**HARRIS COUNTY W.C. & I.D. NO. 110  
ENGINEER'S REPORT  
June 10, 2026**

Subject: Harris County W.C. & I.D. No. 110,  
 Proposed Fence Wall at Fidelis Tract (14.4282  
 Ac. Rec. B of Cypress Forest)  
 LEI Job No. 078-419-101

Submittal No. 1.0

**ABER FENCE & SUPPLY COMPANY, INC.**  
CONCRETE FENCE WALL FOR  
CYPRESS OAKS INDUSTRIAL  
SPRING, TX

**10' BRICK WALL SYSTEM ELEVATION**  
SCALE : NTS

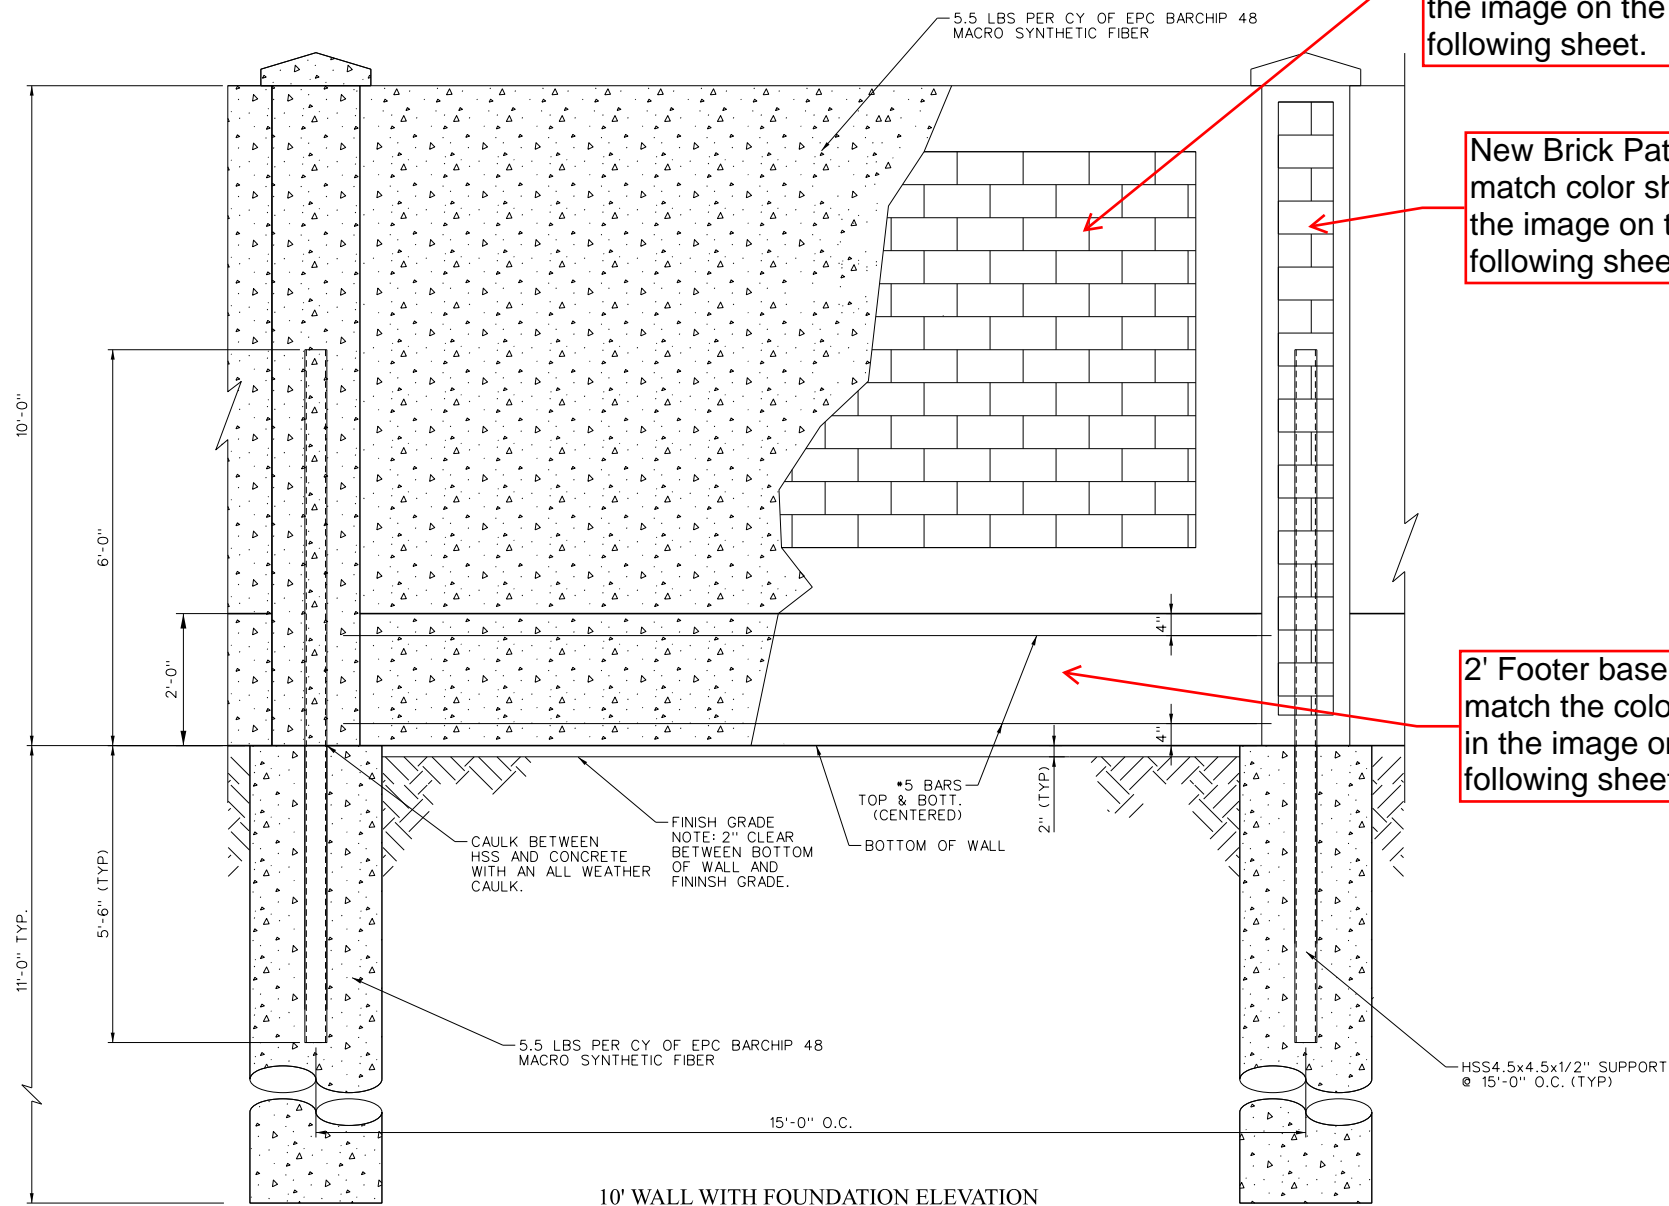
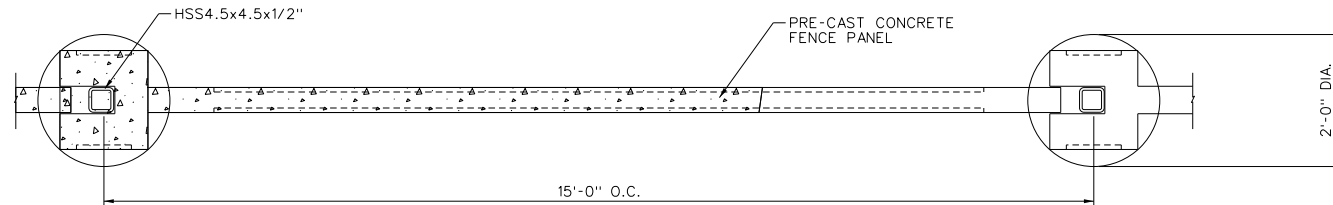
**SEE REMARKS ON THIS SHEET.**

**New Brick Pattern to match color shown on the image on the following sheet.**

**New Brick Pattern to match color shown on the image on the following sheet.**

**2' Footer base color to match the color shown in the image on the following sheet.**
